DOCUMENT CHANGE REQUEST

DCR number 443	Changes required for: N/A	Originator: Benoit Cornanguer
Date: 2008/11/21	Date sent: 2008/11/21	Organisation: CNES
Status: IMPLEMENTED

Title:	Diodes Switching, based on types 1N5802, 1N5804, 1N5806, 1N5802US, 1N5804US, 1N5806US and		
Number:	5101/014	Issue:	1

ESCC Detail Specification No. 5101/014

FIGURE 1 – PARAMETER DERATING INFORMATION (Not Applicable for the variants 13 to 14)

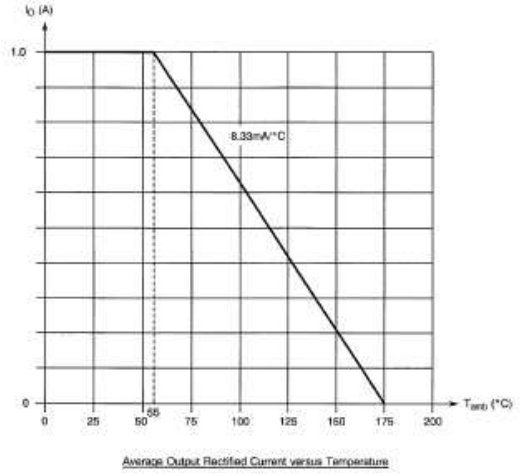
d) Table 1(b), Figure 1
Maximum rating for Average Output Rectified Current IO amended to be 2.5A at Tcase (was 1A at Tamb)(to be consistent with new variants 13 & 14 and MIL-PRF-19500/477). Derating of IO amended for Tcase>75C (to be consistent with MIL-PRF-19500/477).

Justification .
Variant 13: new ST variant introduction with LCC2A package
Variant 14: new ST variant introduction with LCC2A package

Figure 2(d)- Variant 13 to 14 - Leadless Chip Carrier 2 (LCC2A) – 2 Terminal

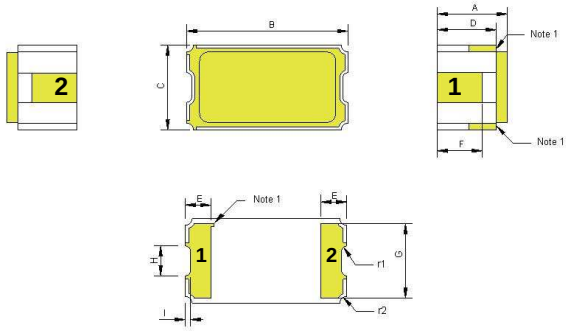
New variants 13 & 14 introduction with LCC2 A package (gold finish and hot solder dip).

Justification .
Variant 13: new ST variant introduction with LCC2A package
Variant 14: new ST variant introduction with LCC2A package
